OIL PRESSURE SENSOR REPLACEMENT Prevost vehicles

Rev B: Added "VBC campaign #"

Special Bulletin

SP14-300B

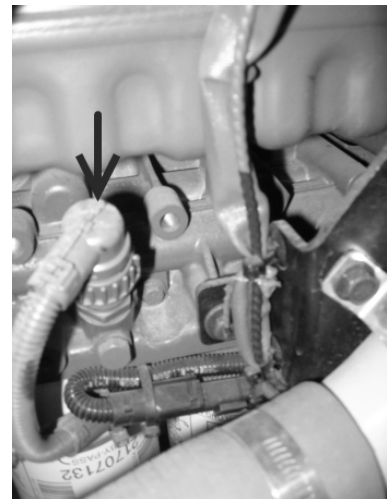
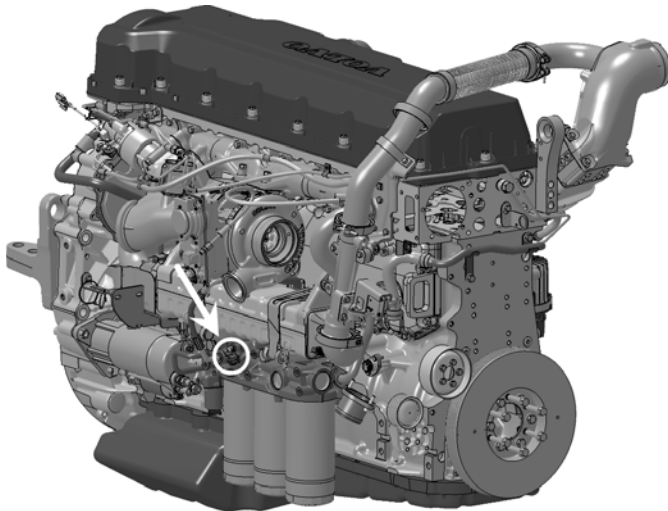
- 1) Disconnect the **PCJ oil pressure sensor** connector rotating the knurled collar counterclockwise. See the images below to locate the sensor.

- 2) Unscrew the sensor from the oil filter housing.
- 3) Inspect the engine harness for oil contamination. If a sensor is being replaced for electrical faults and oil has NOT wicked into the harness, **REPLACE THE SENSOR ONLY.** (p/n 21634021)
 - a. Install the new pressure sensor (p/n 21634021). Torque: 18.5 ± 2 ft-lb.
 - b. Reinstall the connector and rotate clockwise to lock.
- 4) If a sensor has failed **AND** is wicking oil into the engine harness, **REPLACE THE SENSOR AND INSTALL THE JUMPER HARNESS** p/n 22205127.

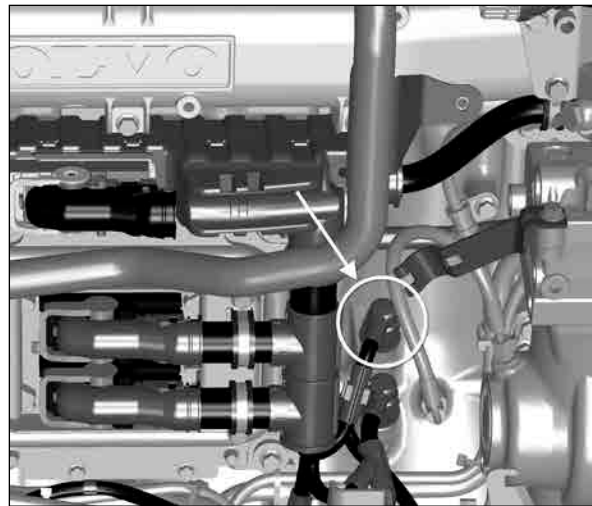
- a. Clip applicable cable ties and remove P-clamps securing the oil pressure sensor harness.
 - b. Disconnect the oil pressure sensor harness from the sensor.

- c. Install the new pressure sensor (p/n 21634021). Torque: 18.5 ± 2 ft-lb.
 - d. Reverse the back shells on the jumper harness connectors before installing the jumper harness.

- e. Clean out the electrical connector pins and sensor mounting surface with contact cleaner. Connect the 90 degree end of the jumper harness to the oil pressure sensor and the straight end to the harness. Install cable ties and P-clamps as necessary.
